UNITED STATES PATENT AND TRADEMARK OFFICE

Office Action Summary	Application No. 10/575,258	Applicant(s) MIGLI, CARLO	
	Examiner Jeffrey O'Brien	Art Unit 3677

DETAILED ACTION

Annotated Fig. 2

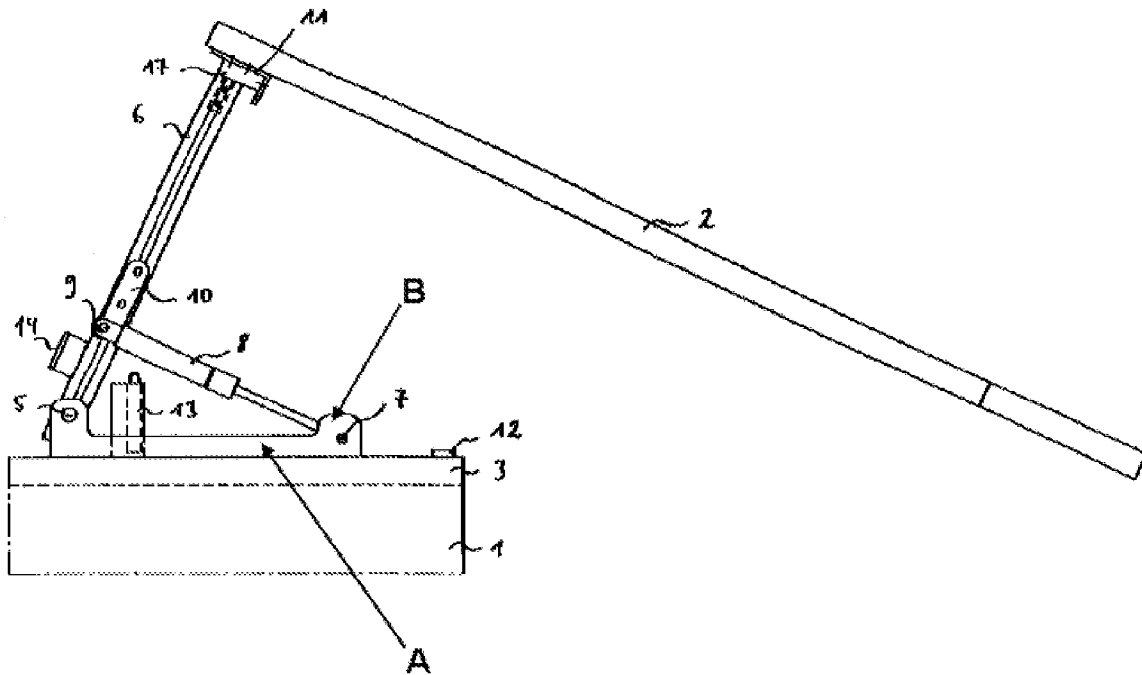
9. For Claim 1, '532 discloses a hinge assembly (Fig. 2) for the connection of a vertically opening panel (2) to an element (1) between a closing position (Fig. 1) and an opening position (Fig. 2) comprising:

a supporting base (annotated Fig. 2: A);

a lifting lever (6) operatively connected to the panel (2) and directly hinged to the supporting base (A) about a first pivoting axis (at 5) between said closing and opening positions of the panel;

a balancing device (8) hinged to the supporting base (A) about a second pivoting axis (7) and acting on the lifting lever (6) along a direction of thrust defined by a line joining the second pivoting axis and a point of application of the thrust on the lifting lever to at least partially counterbalance the weight of the panel during rotation of the lever about said first pivoting axis (as seen in Fig. 2);

wherein the second pivoting axis (7) defines with the first pivoting axis (5) a dead center plane (as seen in Figs. 1-2);

wherein the first pivoting axis (5) and said balancing device (8) are positioned above an upper surface (3) of the element (1) in the mounting position of the hinge assembly (as seen in Figs. 1-2);

wherein in said closing position (Fig. 2) of the panel the second pivoting axis (7) is interposed between the panel (2) and the first pivoting axis (5); and

wherein the direction of thrust of the balancing device during operation is never below said dead center plane (as seen in Fig. 2); and

wherein said balancing device (8) comprises an adjustment device (10) for adjusting the thrusting force exerted by the balancing device on the lifting lever.

27. For Claim 11, '711 teaches the hinge assembly according to claim 10, wherein said hollow body (20) is hinged to at least one supporting wall (22) extending laterally to the supporting base (18). Further, '532 discloses the hinge assembly hinged to a supporting wall (annotated Fig. 2: B) extending from the supporting base (A).
